Docket 50-305
Operating License DPR-43
Kewaunee Nuclear Power Plant
Proposed Technical Specification Change Regarding Heatup and Cooldown Limit Curves and Request for Exemption to 10 CFR 50.60, 10 CFR 50.61, and Appendices G and H of Part 50

Response to the NRC's Request for Addition Information on
Proposed Amendment 160

**RESPONSE TO NRC QUESTIONS REGARDING MARGINS TO BE
USED IN MASTER CURVE INTEGRITY ASSESSMENT FOR
THE KEWAUNEE NUCLEAR POWER PLANT**

Figure 1. Illustration of Margin in RT_{To} Definition

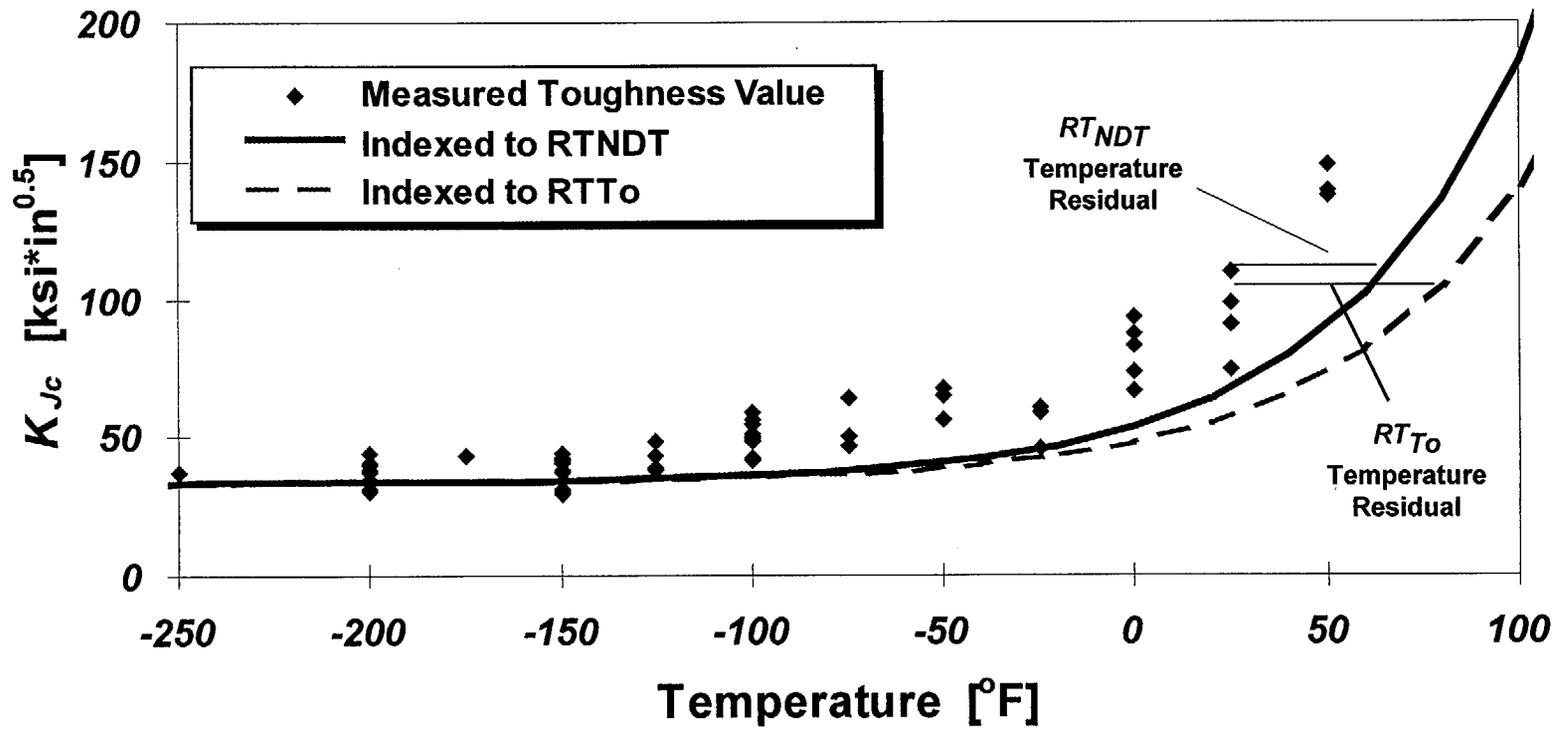
Summary: In the June 7, 1999 submittal, a margin associated with the ratio normalization method and the uncertainty in the measured value of RT_{T_0} was explicitly described. The inherent margin of 18°F, which is built into the determination of $RT_{T_0} = T_0 + 35^\circ\text{F}$, was also presented as an added conservatism to account for other undefined uncertainties. The July 16th letter from the NRC indicated that the margin term from the original submittal might not have included consideration of all pertinent uncertainties. At the October 6th meeting, WPSC explained that the explicit margin associated with the ratio normalization (or heat uncertainty term, as used in the original submittal) closely follows current regulation. The inclusion of the ASTM E 1921-97 standard deviation in the measurement uncertainty in T_0 , and subsequently RT_{T_0} , goes beyond current regulation in that RT_{T_0} is a bounding value not a best estimate. These three terms (the ratio normalization, the explicit margin on the measured value of RT_{T_0} , and the implicit margin included in the definition of RT_{T_0}) constitute a reasonable approach to define an overall margin. These terms account for uncertainties in initial transition temperature, copper, nickel, fluence, and calculation method.

Since the Master Curve technology directly measures the properties of an irradiated material, it does not require measurements of unirradiated material properties to determine fracture toughness. The only place initial properties are used is in the ratio procedure; note that any variation in initial properties has little effect on the ratio procedure as used in the WPSC evaluation. Therefore, uncertainties associated with the measurement of initial properties do not affect the calculation of RT_{T_0} . The potential material variability in the irradiated RT_{T_0} determination has been considered. RT_{T_0} is defined as $T_0 + 35^\circ\text{F}$ and is an empirical bound. RT_{T_0} is similar to RT_{NDT} in that it is also a bounding value. As such, material uncertainty is inherent in its definition. In fact, there is an inherent margin of 18°F on the most-limiting lower bound material, HSST Plate 02, when using the RT_{T_0} approach. As the most limiting material in the original database, HSST Plate 02 establishes the standard for the minimum acceptable spacing between the fracture toughness values and the reference fracture toughness curve (see Figure 1 for illustration). The use of RT_{T_0} provides a more consistent relationship between the data and the curve and increases the minimum acceptable spacing. The implied relationship between the fracture toughness data and the reference toughness curve is illustrated in Figure 1.

A measured RT_{T_0} is equivalent in application to a measured value of RT_{NDT} . RT_{NDT} is a bounding value and no additional margin is needed to cover uncertainty when the quantity is measured. RT_{T_0} also is a defined bounding value. But, in the June 7, 1999 submittal, RT_{T_0} was conservatively treated as a mean value, and the uncertainty in the measurement, due primarily to the known statistical distribution of the fracture toughness data, was added. Given the more appropriate use of the direct measurement methodology, it is expected that measurement uncertainties for T_0 , and hence RT_{T_0} , are smaller than real measurement uncertainties for RT_{NDT} .

Figure 2. Variation in RT_{T_0} with Fluence for Kewaunee and Maine Yankee Materials

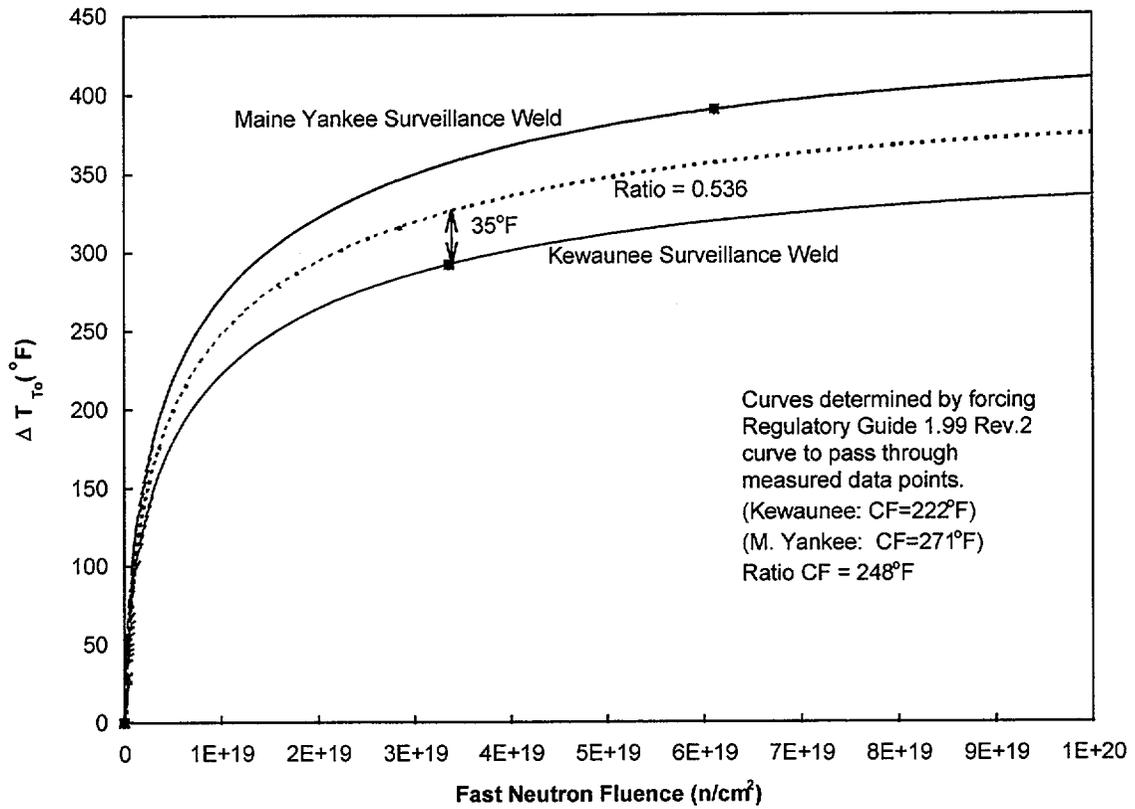
QUESTION 2: If the embrittlement due to copper saturates at a level of 0.30 wt%, what effect does this saturation have on the ratio method used for estimating the best-estimate values for the Kewaunee vessel weld?

The value of R from the Charpy-based approach is an adjustment upward of 39°F above the Kewaunee surveillance weld projections (or equivalently, 32°F below the Maine Yankee surveillance weld projections). Using the measured RT_{T_0} values for the two surveillance welds, instead of Charpy data, results in a ratio adjustment of 37°F above the Kewaunee surveillance weld projections (or equivalently 32°F below the Maine Yankee surveillance weld projections). The higher level of variation in copper for weld wire heat 1P3571 is partially taken into account by the ratio normalization method. In particular, the Maine Yankee surveillance weld exhibits the highest overall mean for copper; the Kewaunee surveillance weld shows the lowest mean level for copper for the 1P3571 heat. The best-estimate copper content for the Kewaunee vessel (using the coil-weighted average of all of the industry data on weld wire heat 1P3571) is essentially midway between the Kewaunee and Maine Yankee surveillance weld mean values. The calculated ratio corresponds to 0.54 between the Kewaunee and Maine Yankee surveillance weld data as shown in Figure 2.

Figure 3. Master Curve Comparison with RT_{NDT} Approach Used to Develop PTS Screening Limits

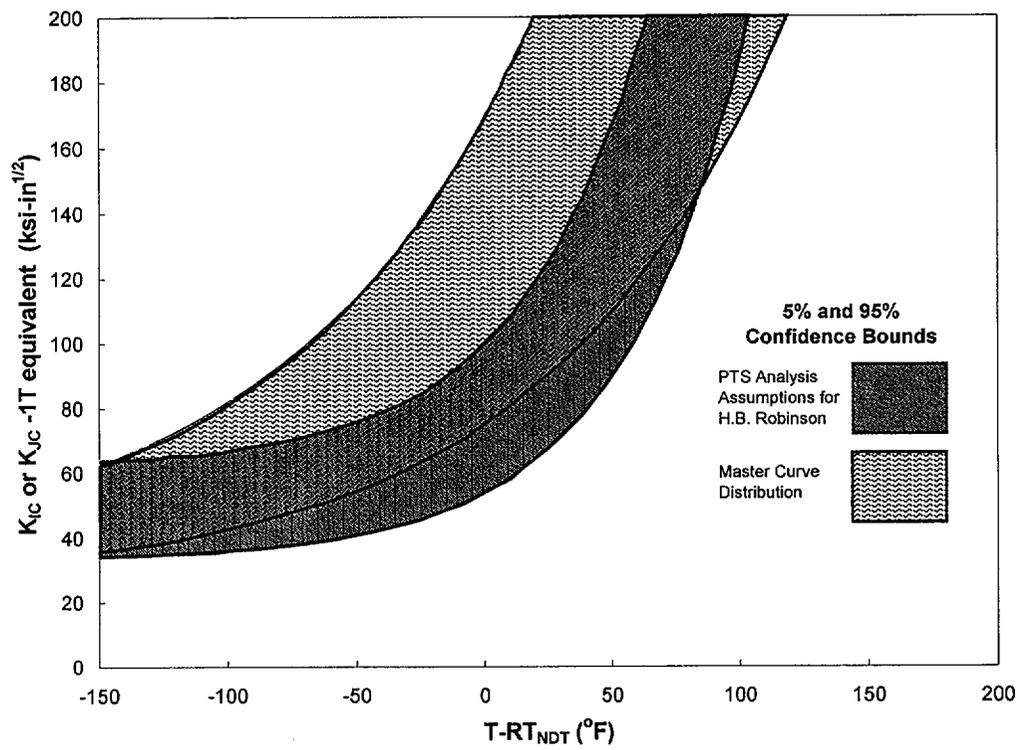
QUESTION 1: How are uncertainties in initial properties, copper, nickel, fluence, and calculation method included in the proposed margin term?

The analysis that established the basis for the PTS Rule, 10 CFR 50.61, was based on an empirical relationship between the ASME K_{IC} toughness curve as indexed by RT_{NDT} and a limited set of fracture toughness data. These distributions may be described in terms of their median values and confidence/tolerance bounds. This comparison is illustrated in Figure 3. Both the mean and the lower (5%) bound curves of the Master Curve exceed the corresponding mean and 5% lower bound for the distribution used in developing the original PTS Rule determination. Substituting RT_{T_0} for RT_{NDT} in the PTS evaluation

results in the relationship between the two distributions illustrated in Figure 3. The range of toughness values indicated by Master Curve confidence bounds is significantly broader than the corresponding range indicated by the confidence bounds used for the PTS Rule. Recent advances in the understanding of the statistical nature of cleavage fracture initiation indicate that the broader Master Curve distribution is more realistic. This distribution is inherent in the definition of T_0 as outlined in ASTM E 1921-97. Therefore, for any measured value of T_0 , the fracture toughness data must lie in the Master Curve range described in Figure 3. The distribution used for the original PTS Rule determination is narrower and concentrates the toughness values nearer the lower bound. The fracture toughness values used to evaluate conditional probabilities of failure in the PTS screening criteria analysis were drawn from this narrower distribution. Fracture toughness values sampled from the PTS distribution are generally low as compared to the more realistic Master Curve distribution. Use of these low values results in an overestimate of the conditional probability of failure. The use of RT_{T_0} in place of RT_{PTS} implies a level of conservatism that exceeds the level implicit in the current PTS screening criteria. This additional conservatism in the analysis is a manifestation of the inherent margin in the RT_{T_0} definition.

Figure 4. Illustration of Cu Saturation Effect on Original Ratio Adjustment (This adjustment does not account for bias in copper distribution, which is addressed in Question 5).

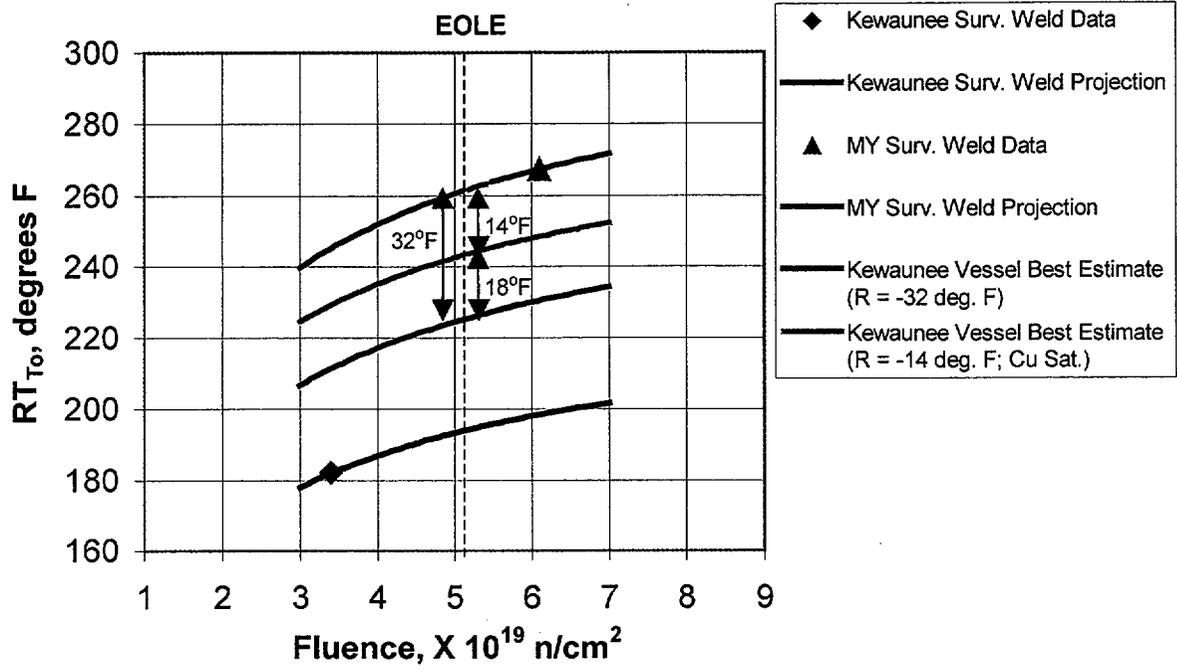
QUESTION 2: If the embrittlement due to copper saturates at a level of 0.30 wt%, what effect does this saturation have on the ratio method used for estimating the best-estimate values for the Kewaunee vessel weld?

In assessing copper saturation at 0.30 wt%, both the use of the weld chemistry factor tables (with copper set at a maximum of 0.30 wt%) in 10CFR50.61/ Regulatory Guide 1.99, Revision 2 and the proposed equations in NUREG/CR-6551 were examined. The change in the ratio normalization increases from 0.54 to 0.81 using either approach. The impact of changing the ratio normalization from 0.54 to 0.81 is an increase of 18°F. The shift of the predicted Kewaunee vessel curve towards the higher Maine Yankee surveillance weld projection is illustrated in Figure 4. Instead of being 32°F below the Maine Yankee projection at EOLE, the copper saturation would occur 14°F below the Maine Yankee projection. Copper saturation, however, also results in a bias reduction in the mean copper estimate for the Kewaunee vessel. This bias adjustment greatly reduces this apparent increase as discussed in response to Question 5.

If copper saturation is included in the direct fracture toughness analysis, the concern for high copper variability in the 1P3571 welds is eliminated. In particular for the Kewaunee vessel, the best-estimate copper content is 0.287 wt%. This value is nearly equivalent to the saturation limit of 0.30 wt%. The difference is only 0.013 wt%, which is much less than the 0.03wt% standard deviation assumed earlier in the analysis to address Question

Figure 5. Coil-Adjusted Distribution of Cu Concentrations for Weld 1P3571

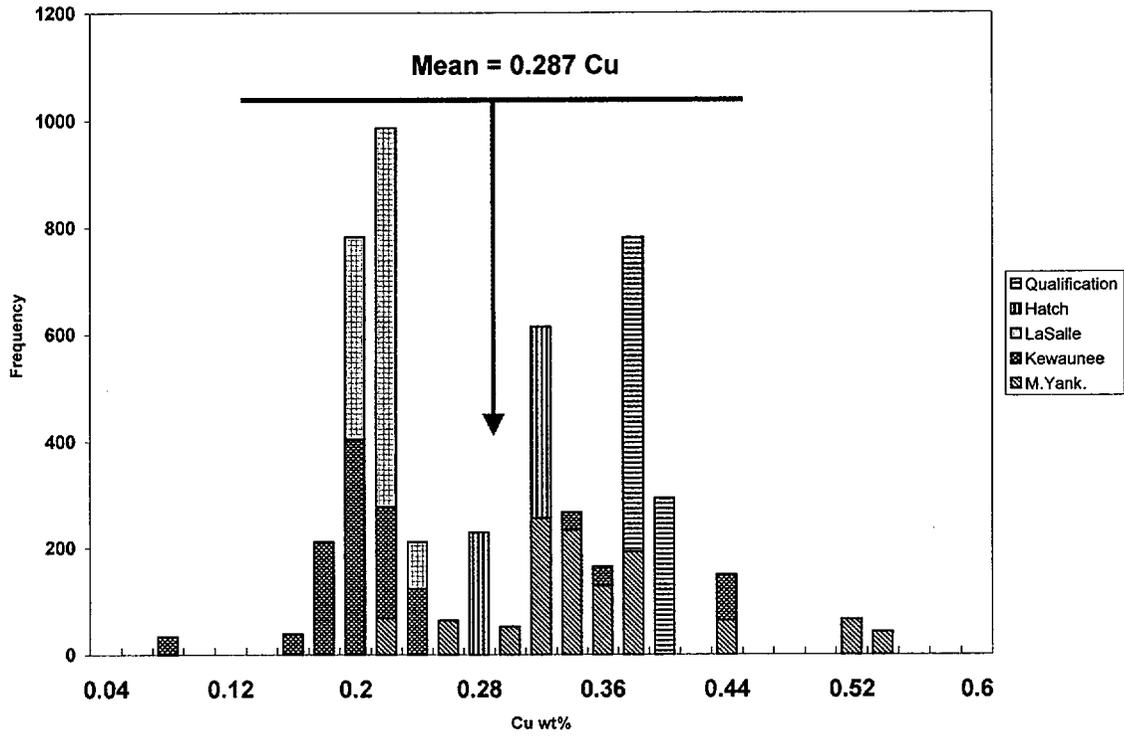
QUESTION 4: What is the effect of the latest understanding of chemistry variability from responses to Generic Letter 92-01 on the margin term?

Technical Approach: The set of chemistry data for welds fabricated from wire heat 1P3571 contains information from six different weldments. These weldments include the Kewaunee, Maine Yankee, LaSalle-1 and Hatch-1 surveillance welds as well as two qualification welds (see Figure 5). These welds were all included in the determination of the coil-weighted average composition, using a weighting scheme that is related to the composition of the weld (see WCAP-15074). As previously indicated, the Kewaunee and Maine Yankee surveillance welds of heat 1P3571 have been analyzed extensively. These two materials exhibit distinctly different Cu distributions. Although the other 1P3571 data sets are smaller it appears that the remaining materials also exhibit characteristic distributions. The ratio method normalizes the measured Charpy shift to the mean behavior of the combined distribution. The mean Cu concentration for this distribution is 0.287 wt% and the standard deviation is 0.08 wt%. The distinct nature of the underlying distributions is clearly evident in the distribution. The width of the $\pm 2\sigma$ band (± 0.16 wt%) in the distribution is also indicated in Figure 5.

The effect of the broadened Cu distribution on the standard deviation of the prediction was evaluated by performing a Monte Carlo simulation process using Regulatory Guide 1.99, Rev. 2 (similar to the previous evaluation of the uncertainty contributions to the

current regulatory margin generated in response to Question 1). 5000 random samples were selected from the illustrated Cu distribution. For this broadened distribution, the Cu portion of the standard deviation of the predicted Charpy shift is increased to 36°F. As indicated in the answer to Question 1, the 0.03 wt% standard deviation on Cu content assumed in the current regulations corresponds to a standard deviation of 13°F in Charpy shift. The factor of 2.8 increase in standard deviation is to be expected given the wide range of Cu levels included in this analysis. The impact on the overall margin term would not be as great since the other key uncertainties are combined using SRSS.

Figure 6. Effective Cu Distribution for Weld Heat 1P3571 Assuming 0.3 wt% Saturation

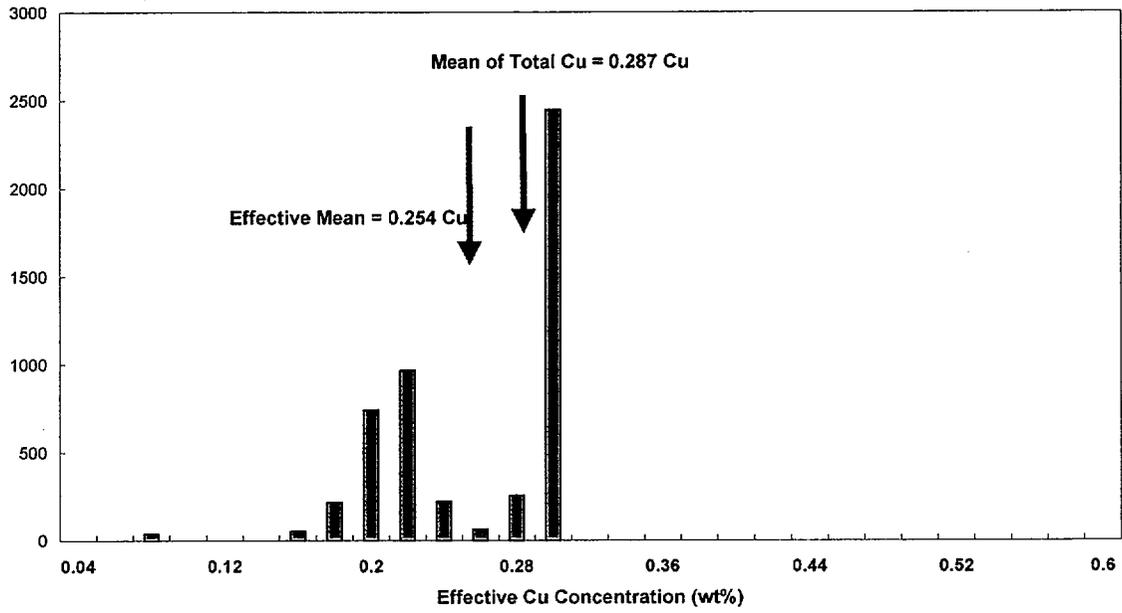
QUESTION 5: What are the integrated effects when considering margins and copper saturation?

Technical Approach: The revised distribution of effective Cu concentrations due to copper saturation is illustrated in Figure 6. In this case, all 1P3571 weld metals with a Cu concentration greater than 0.3 wt% (as shown in Figure 4) are assumed to have an effective Cu concentration of 0.3 wt%. Compressing the high end of the distribution results in a lower mean value and a smaller standard deviation. These effects are obvious in Figure 6.
